# ZURI HYBRID VTOL ANNOUNCED CONSTRUCTION UPDATES

News / Business aviation, Manufacturer

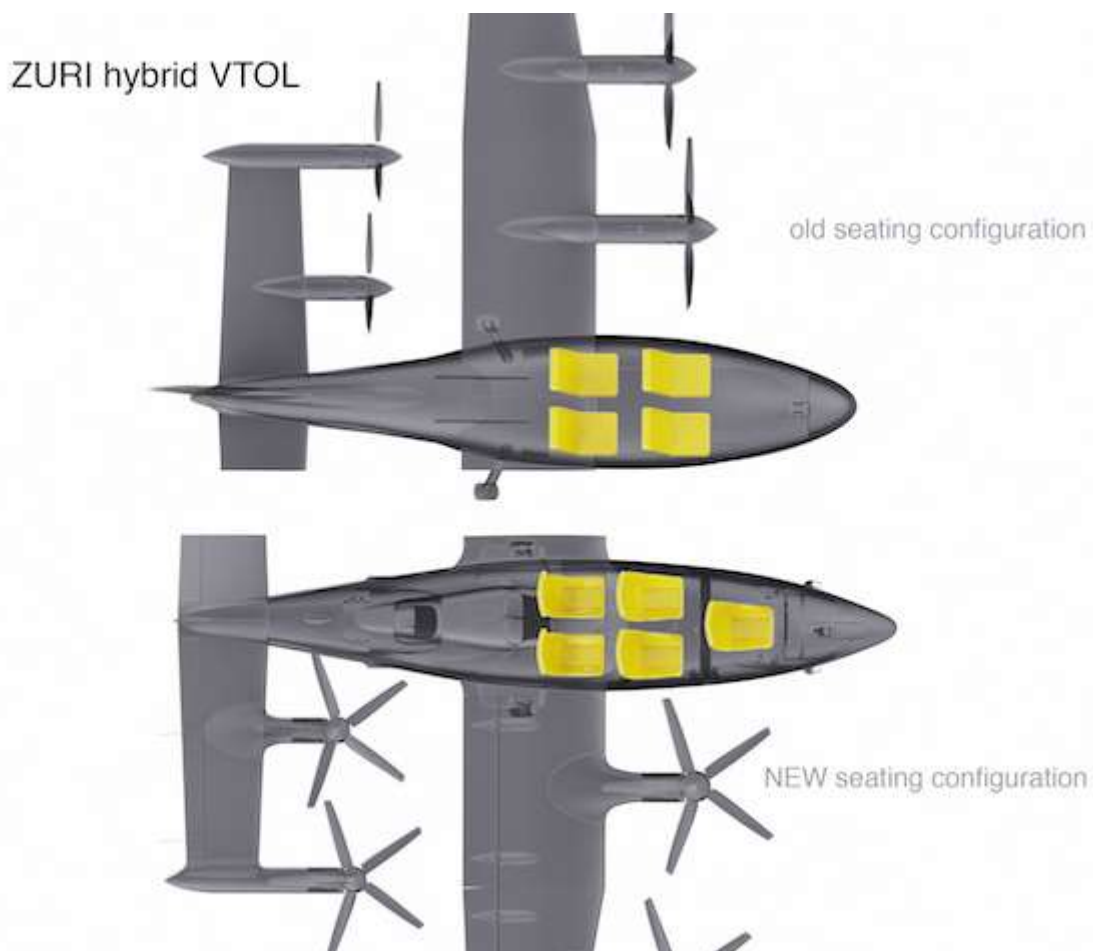
**From the outside, the most significant change has been made at the aircraft's rear. Here, instead of a standard tail with the vertical stabilizer, there is now a V Tail.**

**Such design change will allow for larger propellers and a further increase in the distance between propellers and the ground. Furthermore, using a V Tail should result in lower aerodynamic drag and help in the plane's overall aerodynamics characteristics.**
